Remarks/Arguments

Serial No. NEW
OKI.480C3
Preliminary Amendment dated March 31, 2004

Fig. 8

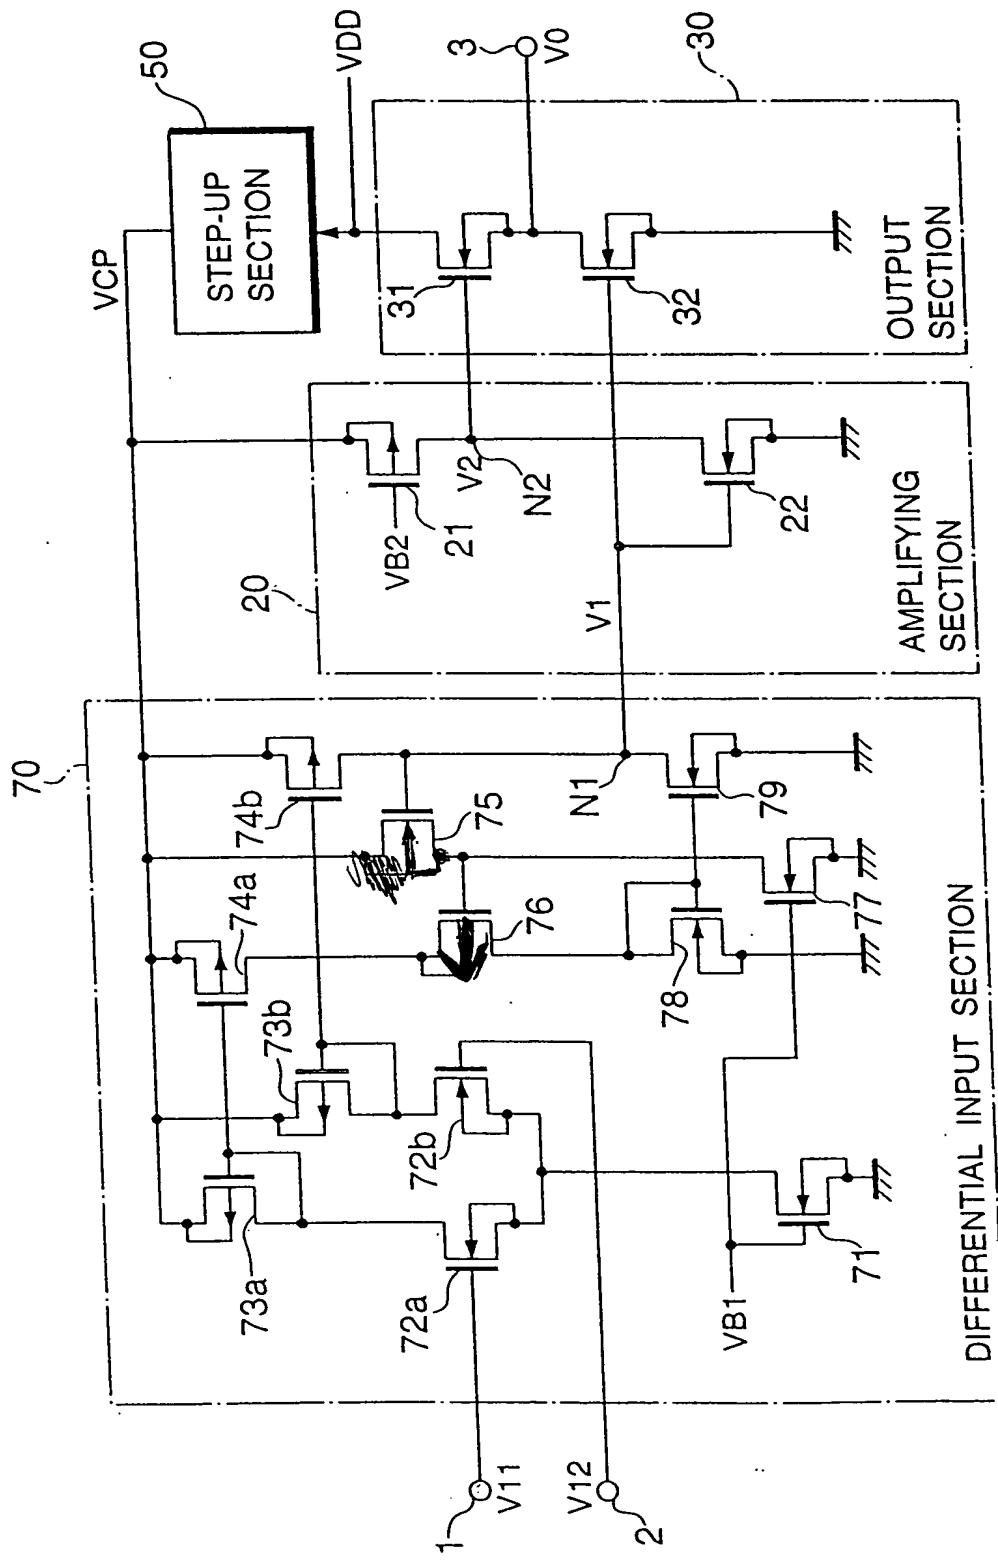
With regard to the drawings, Fig. 8 has been corrected as indicated in the red-inked Annotated Marked-up Drawings enclosed herewith, wherein MOS transistor 76 has been illustrated correctly as p-channel as supported on page 16, lines 1-3 of the application, and the depiction of n-channel MOS transistor 75 has been corrected.
